Authorisation Number: CAR/L/1129793

Variation Number: VAR04

Notice: Variation of Authorisation

| Authorised Place: | Tabhaigh MPFF |

Figure 1 *Fish Pen Location*

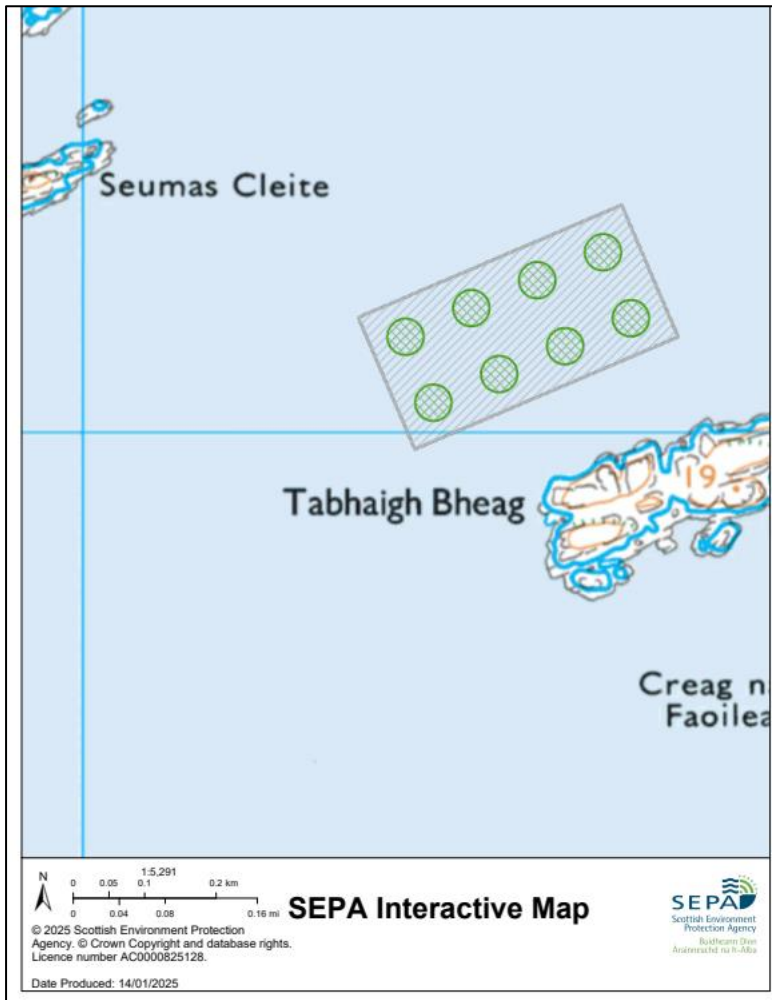
- Condition 2.4 is deleted and replaced by a new condition 2.4 as follows:

2.4 Pen Configuration

2.4.1 The fish pens must be configured as set out in Table 1.

2.4.2 The authorised location of the fish pen group is within an area delineated in Figure 1 and bounded by the pen corner buoys located at the following National Grid References (NGRs):

- NB 4138 2316 (NW)
- NB 4175 2331 (NE)
- NB 4183 2313 (SE)
- NB 4146 2297 (SW)

2.4.3 The pen corner buoys must not be located at a distance greater than 50 metres in any direction from the NGRs listed in 2.4.2.
